DEVIATION REQUEST AND DECISION FORM

Project Name :	Sterling Ranch Sand Creek Channel Construction Drawing Review CDR 20-4
Schedule No.(s) :	5227301021, 5233309027, 5228000030 & 38, 5233301001 5233301016 &17
Legal Description :	See Exhibit B – Legal Description

A deviation from the standards of or in Section **ECM section 3.3.3 Open Channel Design Standards** of the Engineering Criteria Manual (ECM) is requested for the Sand Creek Channel Design – Low Flow Channel Capacity.

Exhibit A

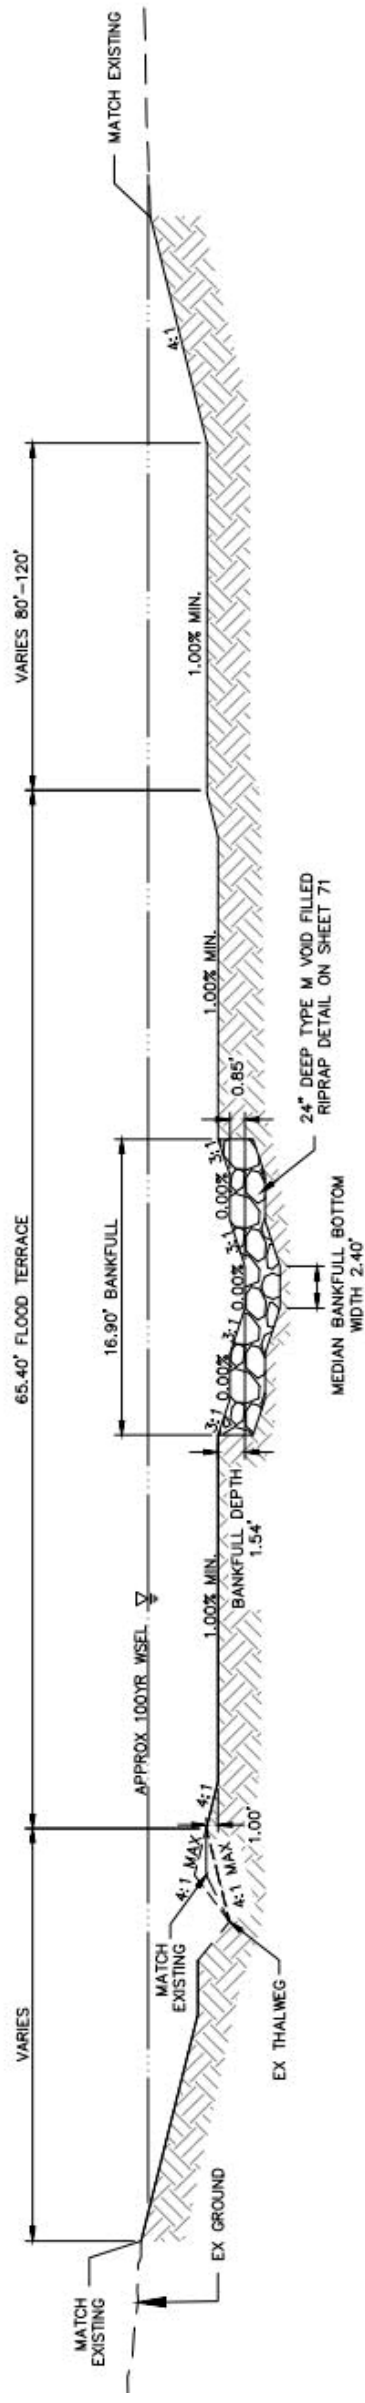
See Exhibit A for a representation of the “geomorphologist recommended” low flow channel cross section.

The proposed low flow channel in the Sterling Ranch Sand Creek design is approximately 16.9 feet wide and 1.54 feet deep and has a capacity of 29 cubic feet per second. The low flow channel is armored with 24” deep type M void filled rip rap.

The geomorphologist's reasoning for the smaller low flow channel cross section was that base flows in this reach of the channel are a fraction of the ECM criteria. Base flows in this portion of Sand Creek are a fraction of the required low flow capacity and the required low flow channel would be far larger than necessary to deal with the base flows, eventually leading the channel to cut its own low flow section for base flows. By using a narrower multi-stage section within the bankfull, dense vegetation can establish itself, particularly along the inner berm. Instead of the bankfull being sized for the larger events, the flood terrace has been sized to convey the two year storm. The frequency that the flood terrace sees inundation will also allow for denser vegetation within the flood terrace extents. Since the bankfull will be carrying a smaller proportion of the larger events, the floodplain is wide enough to ensure that flow depth remains low outside of the flood terrace. Shear stresses in the overbanks are low enough that seeding and riparian plantings will be sufficient to withstand the high flow events, with only a few areas requiring more substantial treatment.

This request is not based on financial considerations. The primary reason for the reduced size low flow channel is keep base flows contained and allow for a wide shallow flood terrace to promote dense wetland vegetation growth.

Maintenance of the low-flow channel shall be by the Sterling Ranch Metro District.

Full stabilization and vegetation density will be required prior to preliminary acceptance
